BLM layout around Crystal Collimators

BLM Thresholds Working Group 12th March 2021

Crystal collimators in IP7

Inspection of TCPCH.A4L7.B1

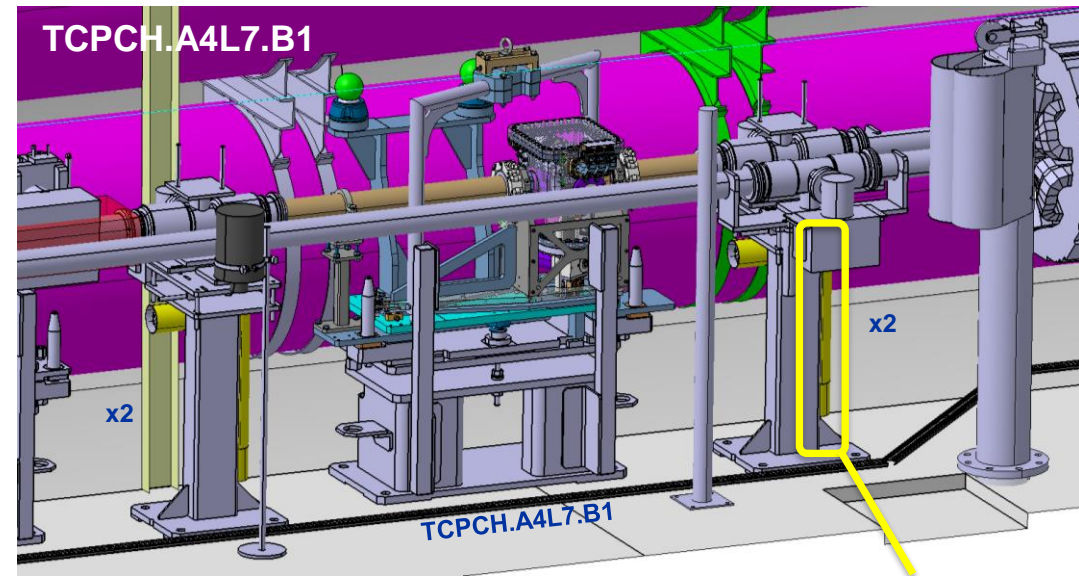
The BLM associated to the empty slot (TCSM.D4L7.B1) should be re-assigned to the crystal.
BLMEI -> BLMTI

BLMEI-04L7.B1E10_TCSM.D4L7.B1 is
downstream the TCPCH.A4L7.B1

BLMES.04L7.B1E10_TCSM.D4L7.B1 -> BLMTS.04L7.B1E10_TCPCH.A4L7.B1

BLMEI.04L7.B1E10_TCSM.D4L7.B1 -> BLMTI.04L7.B1E10_TCPCH.A4L7.B1

TCPCV.A6L7.B1

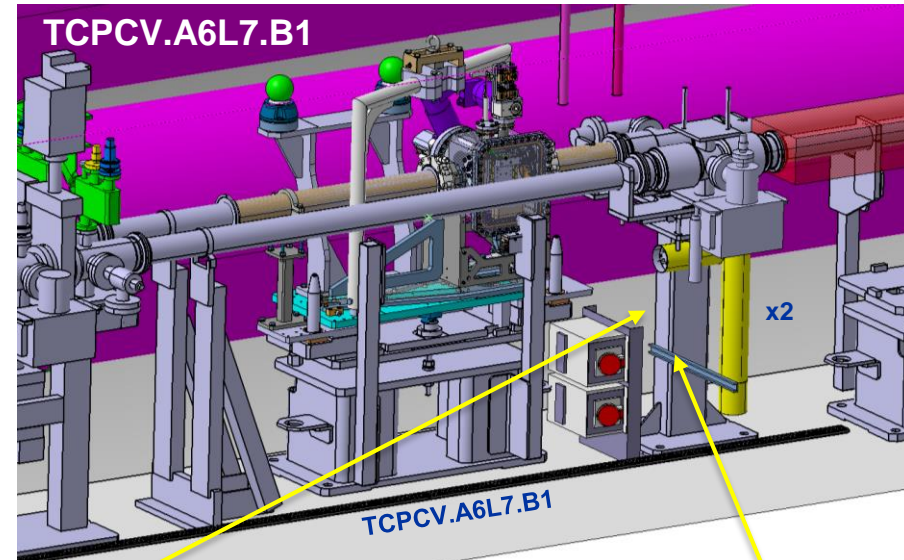
There isn't a BLM for the crystal, only for the TCSM Internal B2.

Collimation was using as measurements the BLM from the other beam.

Metallic bars agreed by E.Page to be removed

Proposal:
Install an additional external BLM right next to TCSM.6L7.B2 BLM

Inspection of TCPCV.A6L7.B1

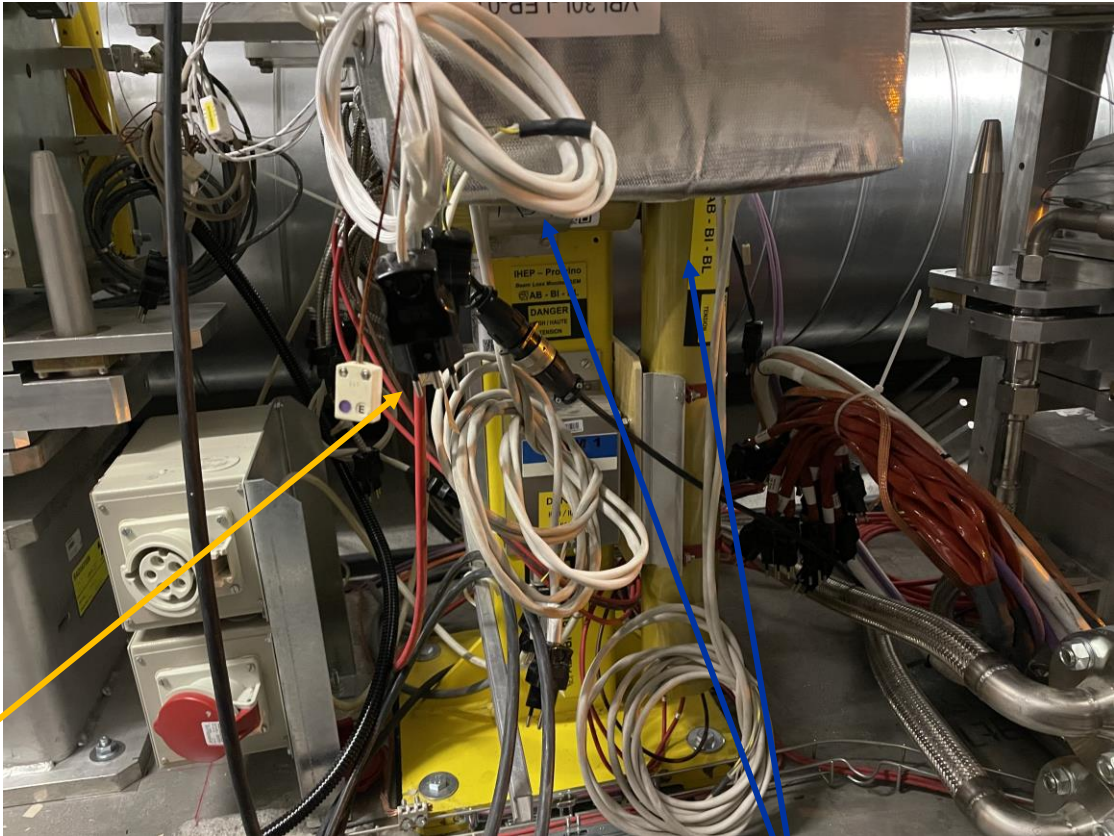
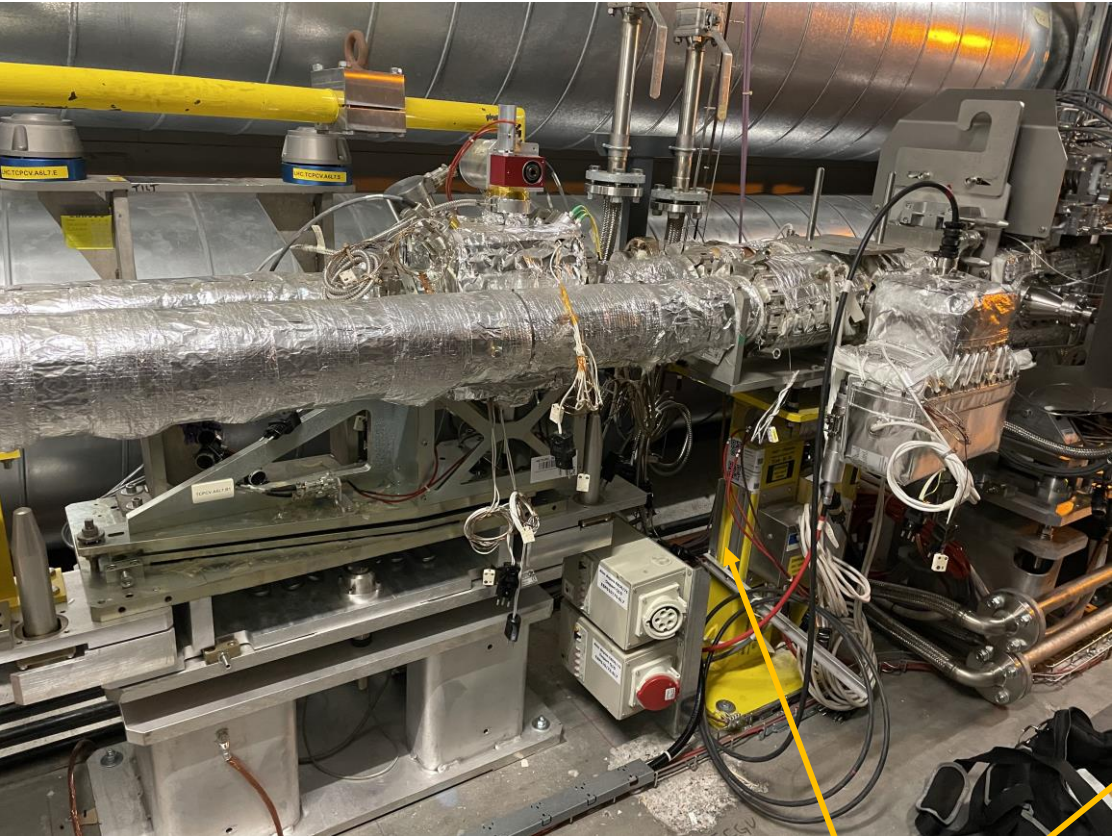
BLM IC and LIC
for TCSM.6L7.B2

Proposal:
Install an additional external BLM right next to TCSM.6L7.B2 BLM.
Only one Ionization Chamber. We can use the spare channel from
the warm magnet (removed in LS2)

Inspection of TCPCH.A5R7.B2

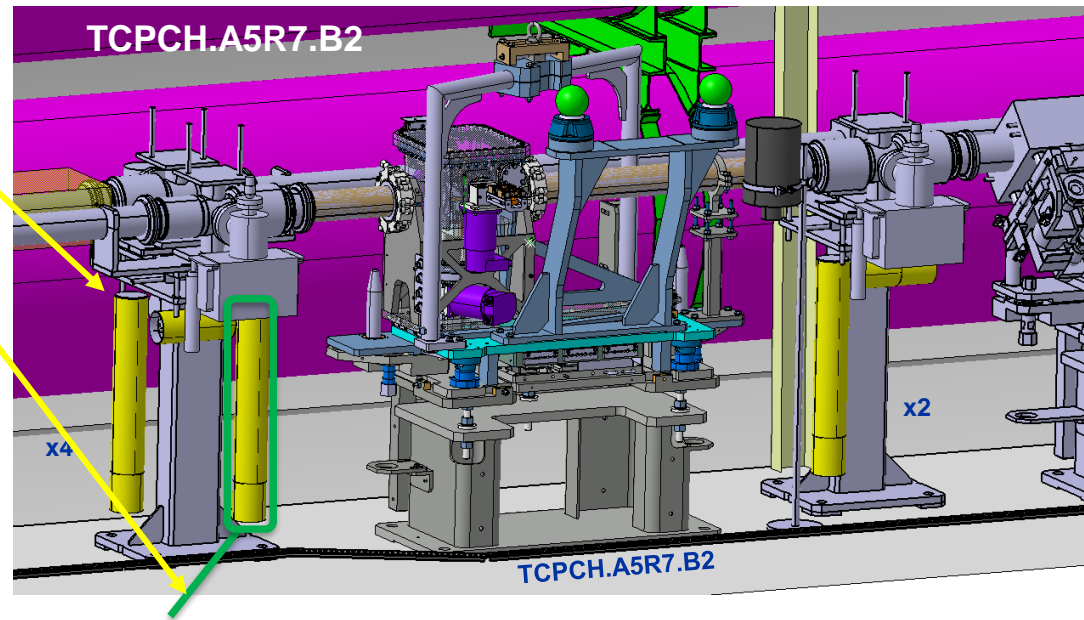
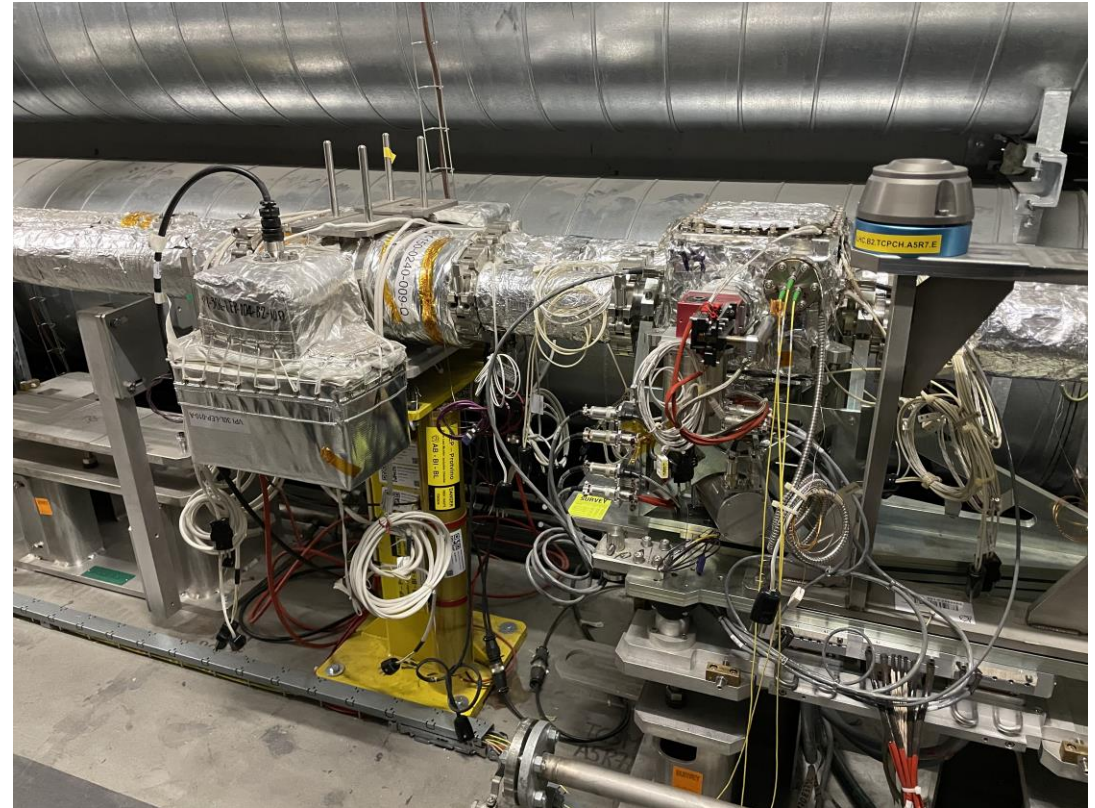
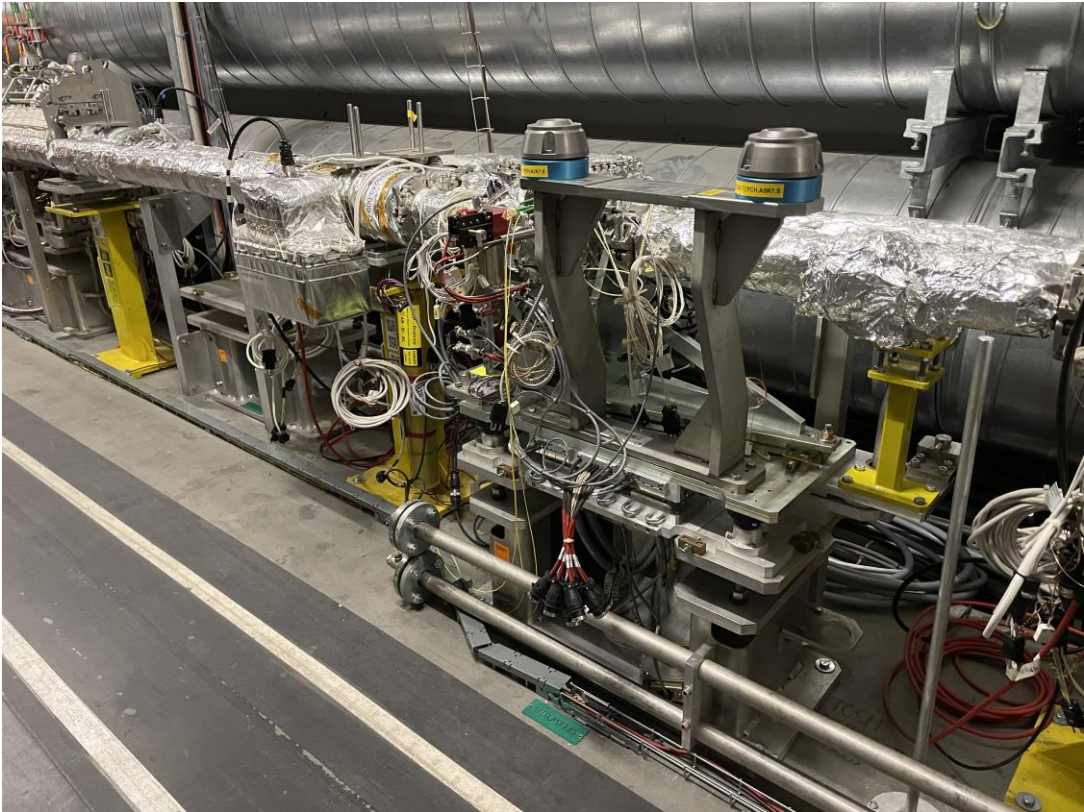
BLM for TCSM.B5R7.B1 and TCPCH.A5R7.B2 crystal already installed in the same support.

Proposal:
Nothing to be done, all OK

TCPCV.A6R7.B2

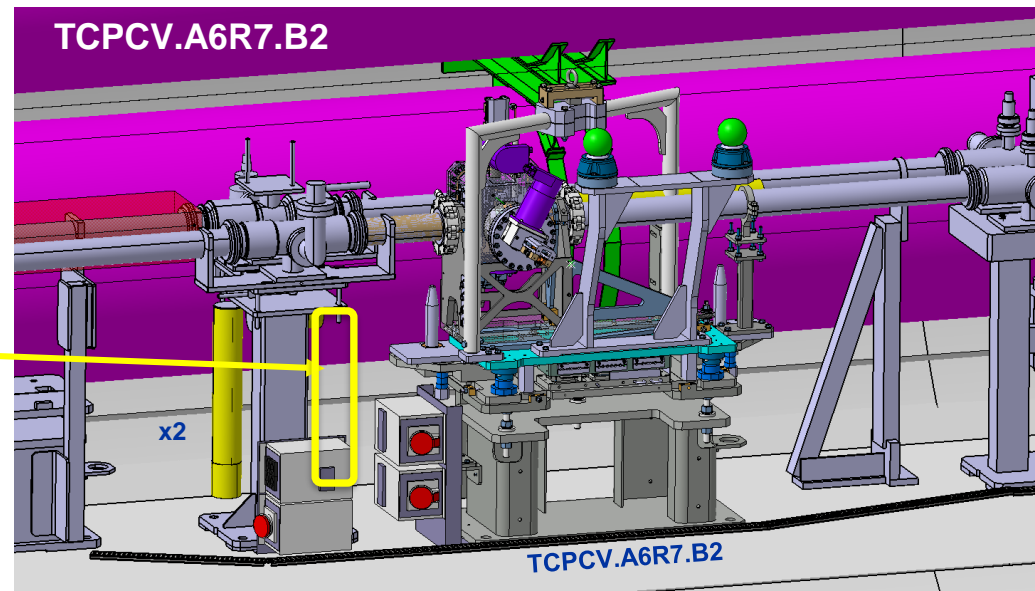
BLM TCPC.A6R7.B2 is upstream the crystal (confirmed with tunnel inspection)

BLM at empty slot TCSM.6R7.B1 are just downstream the crystal

Electrical boxes will need to be displaced in order to allow alignment team to access that area

Proposal:
Displace the existing
BLMTI.06R7.B2I10_TCPC.A6R7.B2 to the same
support as the BLM TCSM.6R7.B1
